Access Compliance Report

Public Rights-of-Way

(Curb Ramps)

Intersection ID: 24592	Main Street: GREYABBY_CT	Cross Street: MALLOW_PL	Location: SE
ADA ID: FFBA837E3268	Ramp Type: PerpDiag	Initial Pass/Fail: Fail	Overall Compliance: No
Severity Score: 13.75			
Codes/Mitigation Info/Possible Solution		Field Measurements/Component Compliance

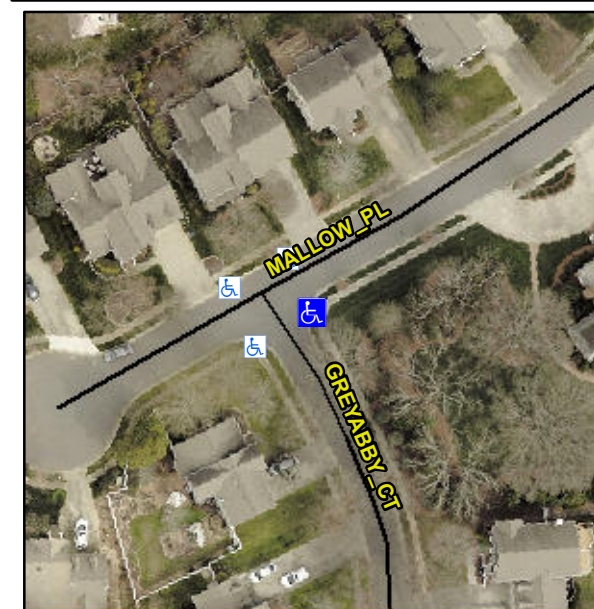
Not Found, R304.2.2, R304.5.3

Compliance	Description	Data	Compliance	Description	Data
N/A	Ramp Length (in)	48.0	No	Ramp Slope (%)	9.1
Yes	Ramp Width (in)	48.0	No	Ramp XSlope (%)	3.6
N/A	Flare Type LT	N/A	N/A	Flare Type RT	N/A
N/A	Flare Slope LT (%)	N/A	N/A	Flare Slope RT (%)	N/A
N/A	Flare Traversable LT?	N/A	N/A	Flare Traversable RT?	N/A
N/A	Landing Length (in)	N/A	N/A	DWS Provided?	N/A
N/A	Landing Width (in)	N/A	N/A	DWS Contrast?	N/A
N/A	Landing Slope (%)	N/A	N/A	DWS Length (in)	N/A
N/A	Landing X Slope (%)	N/A	N/A	DWS Full Width?	N/A
N/A	Landing Curb? (Y/N)	N/A	N/A	DWS Offset (in)	N/A
N/A	Shared Landing?	N/A			
N/A	Gutter Ponding?	N/A	N/A	Gutter Slope (%)	N/A
N/A	Gutter Lip Ht (in)	N/A	N/A	Gutter X Slope (%)	N/A
N/A	Painted X Walk1?	No	N/A	Painted X Walk2?	No
	X Walk 1 Direction	To N		X Walk 2 Direction	To W
N/A	X Walk 1 Width (in)	N/A	N/A	X Walk 2 Width (in)	N/A
	X Walk 1 Slope (%)	2.6		X Walk 2 Slope (%)	0.6
	X Walk 1 X Slope (%)	1.5		X Walk 2 X Slope (%)	3.0

Remove & Replace Curb Ramp With Two New Directional Ramps or Equivalent.
